KIT 403		
QTY / UNIT	MODEL USED ON	ASS'Y NO.
APPLICATION		
CODE

QTY. REQ.	ITEM	PART NO.	DESCRIPTION	SYMBOL
LIST OF MATERIAL				
FINAL APPROVAL			DATE	THE TECHNICAL MATERIEL CORP. MAMARONECK, NEW YORK
MECH. DES.			DATE	
ELECT. DES.			DATE	
CHECKED			DATE	SCHEMATIC, KIT 403 OVERALL WIRING DIAG.
DRAWN			DATE	
SIZE	CODE IDENT. NO.	DWG NO.	ISSUE	
C	82679	CK2095	1	
SCALE			SHEET	OF
			1

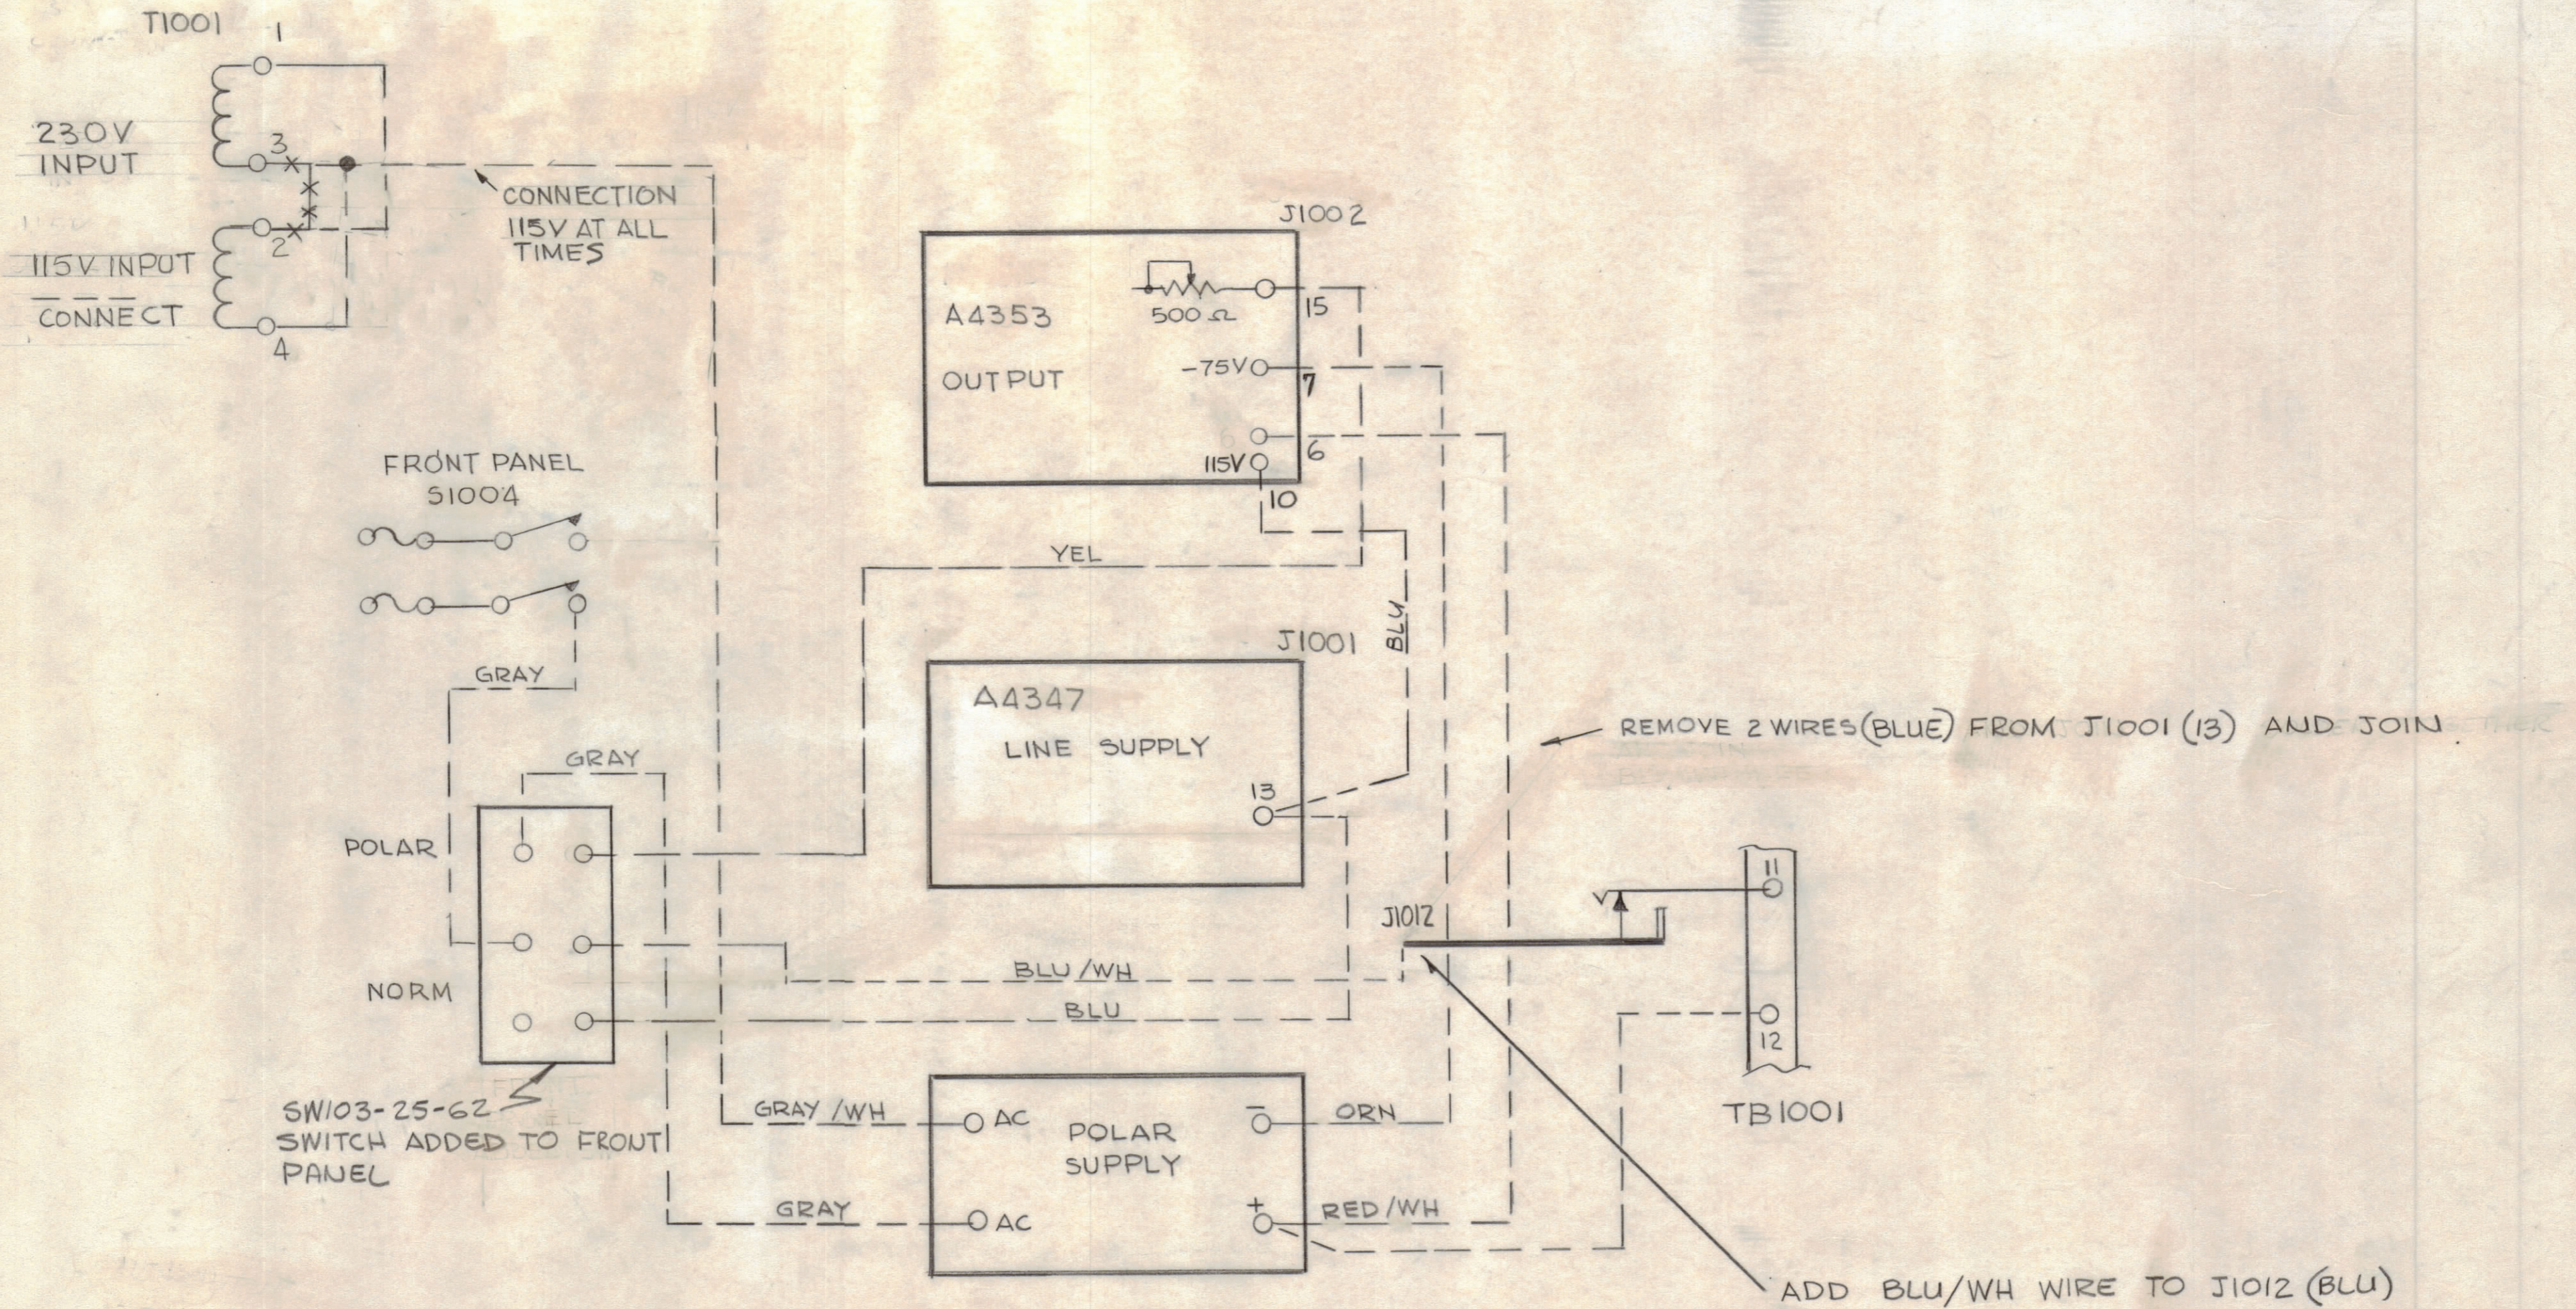
SW103-25-62
SWITCH ADDED TO FRONT
PANEL

REMOVE 2 WIRES (BLUE) FROM J1001 (13) AND JOIN THEM

ADD BLU/WH WIRE TO J1012 (BLU)
